Memorandum

FOUNDATION INVESTIGATION REPORT

Lynn River Bridge Widening
W.P. 53-71-02. Bridge Site 20-70
Hwy. 3, Simcoe
District 2, London

Lynn River Bridge Widening
W.P. 53-71-02, Site No. 20-70
Hwy. 3, District 2, London

WIDENING OF LYNN RIVER BRIDGE
Approx. 0.12 miles east of Hwy. 24
GENERAL LAYOUT

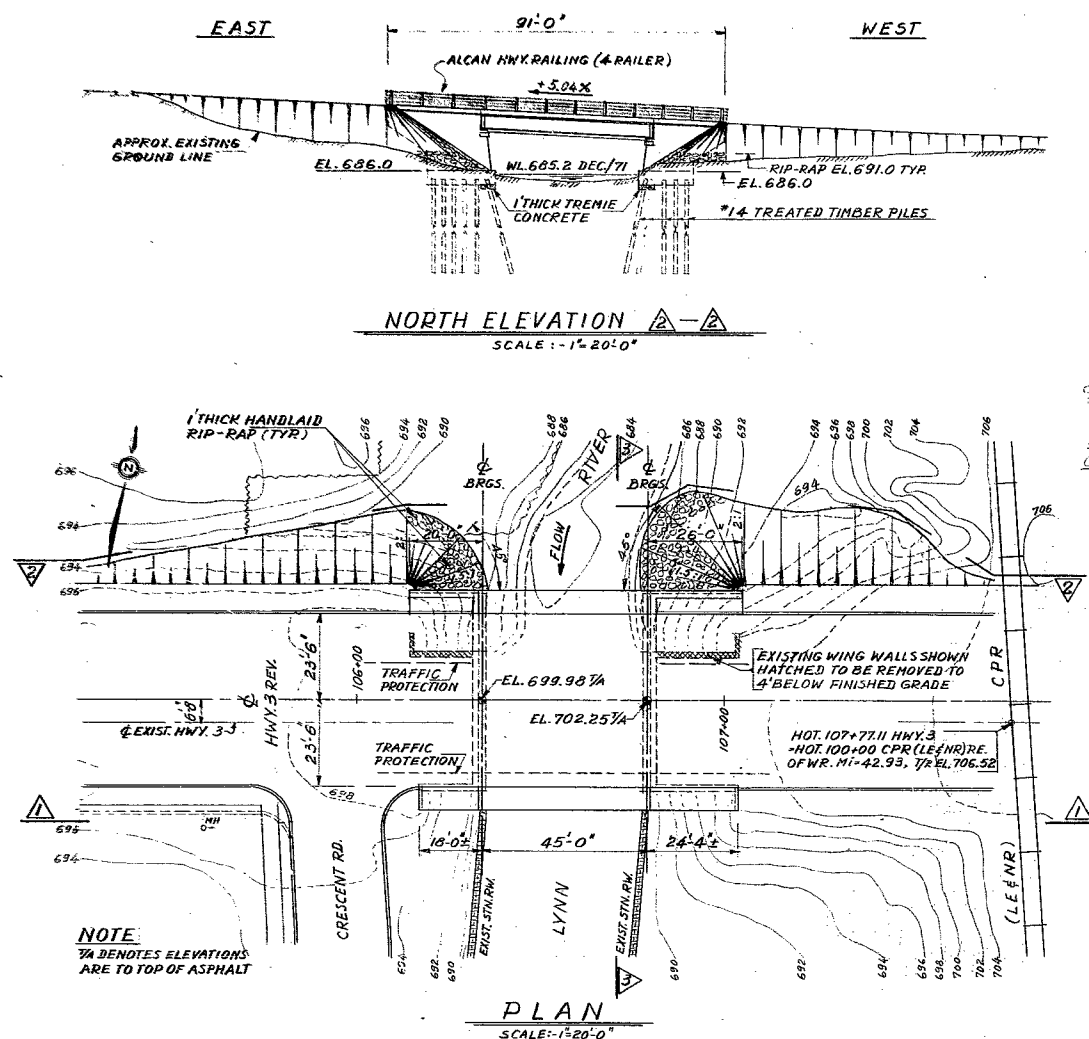
We have reviewed the final design drawings (Dwg. No. 20-70-1 & 3) of this project. Our comments are as follows:

WIDENING OF LYNN RIVER BRIDGE
Approx. 0.12 miles east of Hwy. 24
FOOTINGS

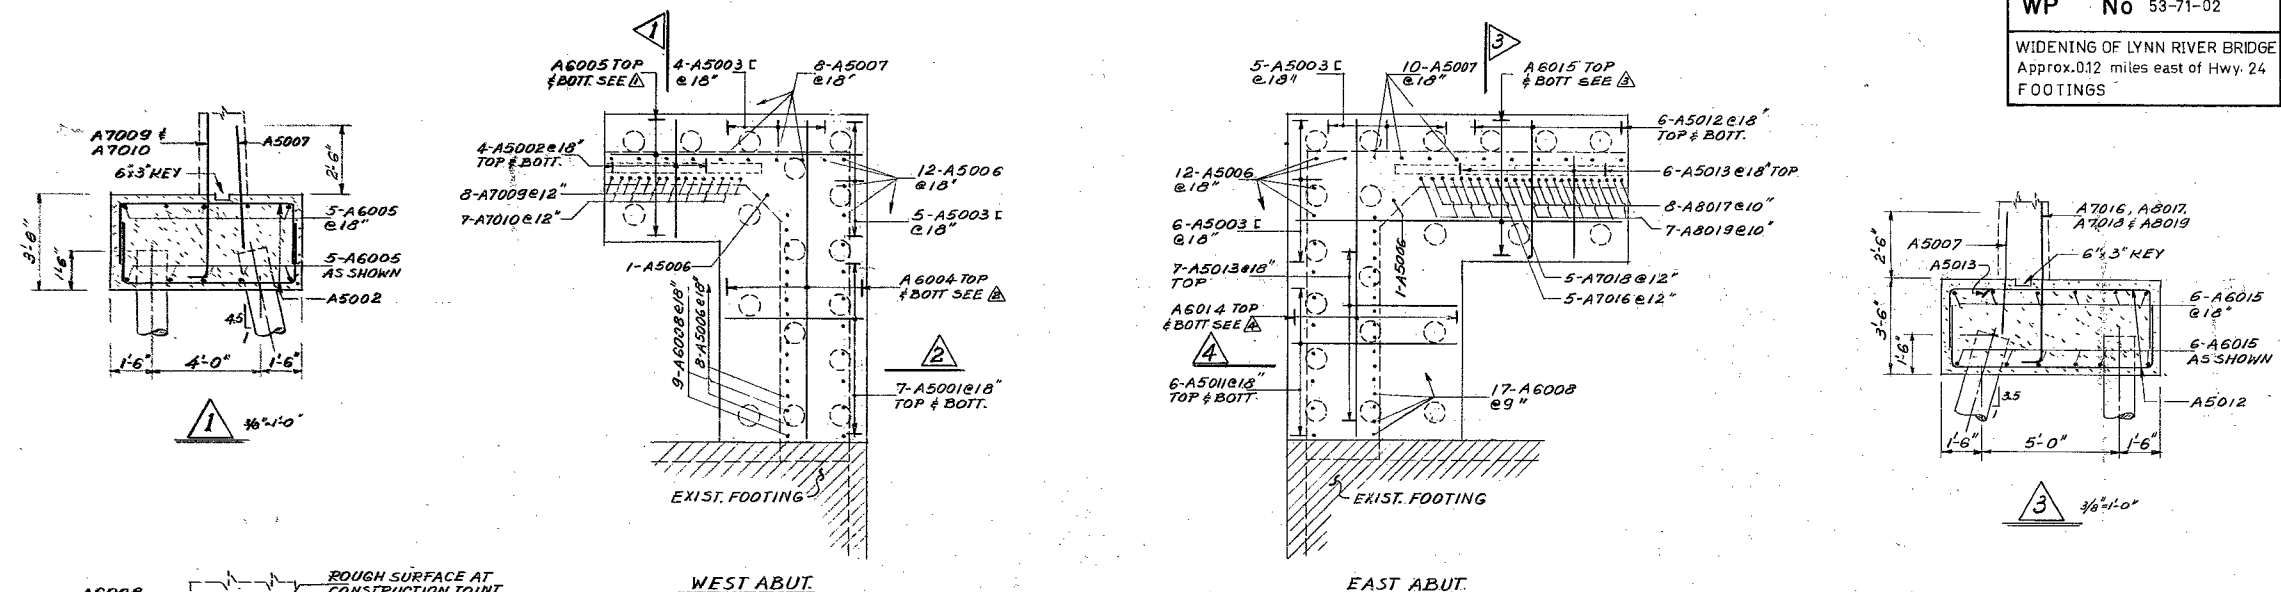
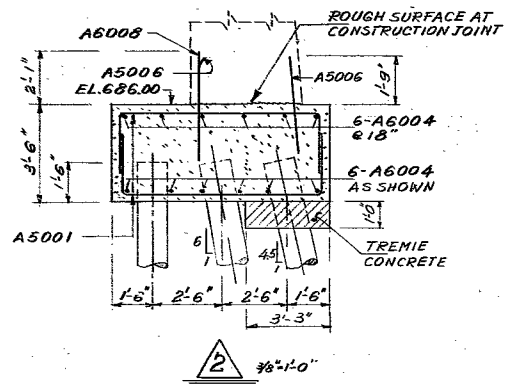
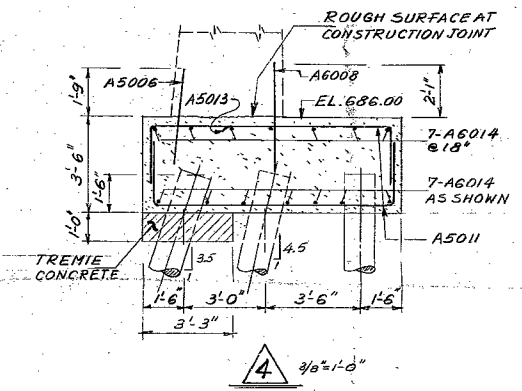
After having re-appraised the subsoil conditions, we feel the capacity of the 55 ft. long treated #14 timber piles can be increased from 20 tons per pile to 25 tons per pile and the pile driving should be controlled by Hiley formula (MTC Standard SS-3-11).

A dewatering scheme will be required for pouring the pile caps, as mentioned in our foundation report.

Further to our memorandum dated May 10, 1976 we have again reviewed the piling requirements for the above mentioned project. We are now of the opinion that the lengths supplied should be 45 feet rather than the 55 foot lengths originally approved by us. The design load should be as recommended in our May 10th memorandum, i.e. 25 tons/pile.

- NOTES
- DESIGN LOAD 25 TONS / PILE
 - SPACINGS OF PILES ARE MEASURED AT UNDERSIDE OF FOOTINGS (TOP OF TREMIE CONC.)
 - PILES TO BE TREATED
 - PILING - CREOSOTE - 8% C.F. RETENTION
 - PILE CUT OFF EL. 684.00 TYPICAL
 - PILES TO BE DRIVEN IN ACCORDANCE WITH STANDARD SS3-II USING DESIGN LOAD 25 TONS / PILE
